OFFICIAL NOTICE NO. 91
PROJECT 1

Addendum No. 1

PROJECT: NO. 1301-13-71 HWY: LOCAL ROADS COUNTY: MILWAUKEE

TRAFFIC AND LIGHTING DETAILS

PLLOT SCALE: 1:40:1 SHEET 30A E

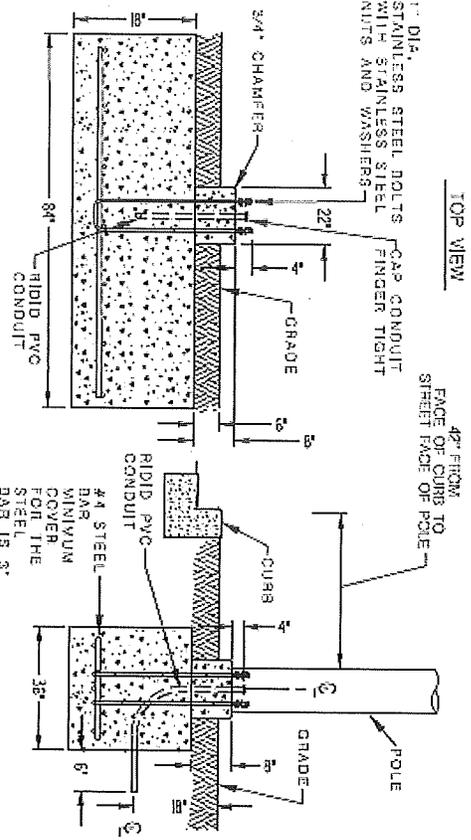
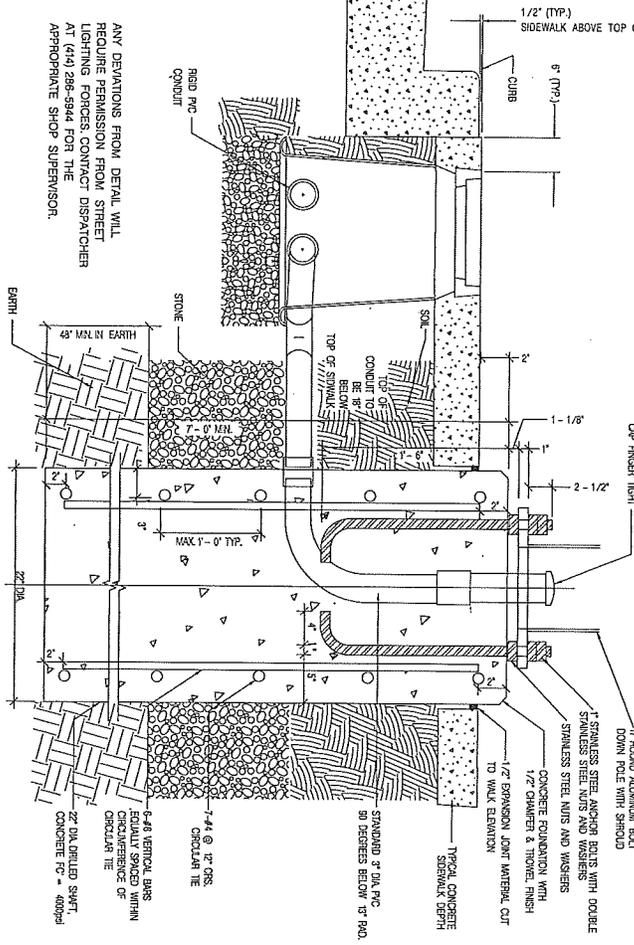
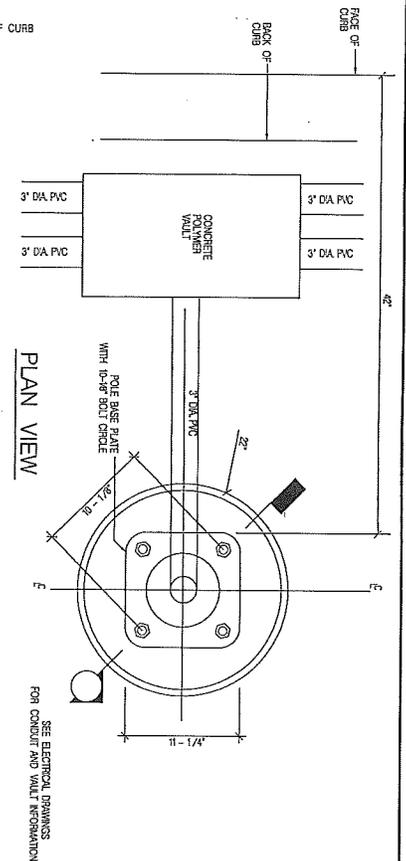
The following plan sheets are attached and made part of the plans for this proposal:
Replace Plan Sheets 29 and 30 with Plan Sheets 29 and 30A
